FINAL RECOMMENDATION OF THE EAST DESIGN REVIEW BOARD

Project Number: 3012437

Address: 1620 12th Ave

Applicant: Dean Kralios, SMR Architects for Capitol Hill Housing

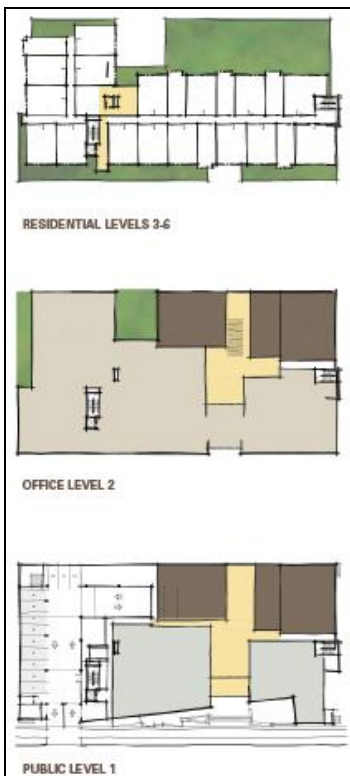
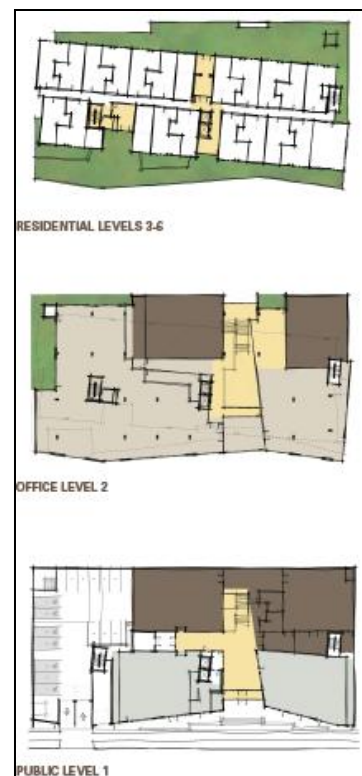
The first scheme (Option A) showed an L-shaped configuration. At the ground level, this scheme held a strong corner facing Pine Street, but provided a recessed area for the entry and creates an exterior space for restaurants and retailers to engage the street. Separate pedestrian and retail

entries were provided. The second level offices front the street edge, while the residential levels were set back ten feet to make a stronger two-level building at the street. The residential units encroached on the rear setback, requiring a departure.

The second scheme (Option B) showed a bar-shaped scheme that responded more directly to the historical and contemporary context. To achieve this, both the ground level and second level provided a continuous street edge. The residential levels provided an efficient floor plan and the orientation and setback for power lines strengthened the relationship with the design guidelines and the neighborhood context. No departures were required for the residential levels.

The third and preferred scheme (Option C) showed a rotated massing scheme. This scheme promoted a building that is more civic in nature, with a distinct entry, strong street presence. At the ground level, a setback provided a central grand entry, highly visible from Pine Street. Additional space for restaurants and retail uses at ground level was provided. The second level built upon a civic presence through unique massing and a veil of fenestration. The residential levels reinforced the neighborhood goals of a two story street presence -- and allowed the public building to be the dominate feature -- while the private building faded to the background. This scheme created a west and north facing courtyard and provided a quieter south and east facing deck as a buffer to the low rise zone to the east. The same efficient floor plan as Option B was provided, however, this scheme required a small encroachment into the rear setbacks at level two and at the top two levels.

At the Early Design Guidance Meeting, the Board encouraged the three building forms of the preferred option to relate to each other and be perceived a part of one design concept. The Board enthusiastically supported the diagonal configuration of the upper levels as a sensitive solution to the zone edges.
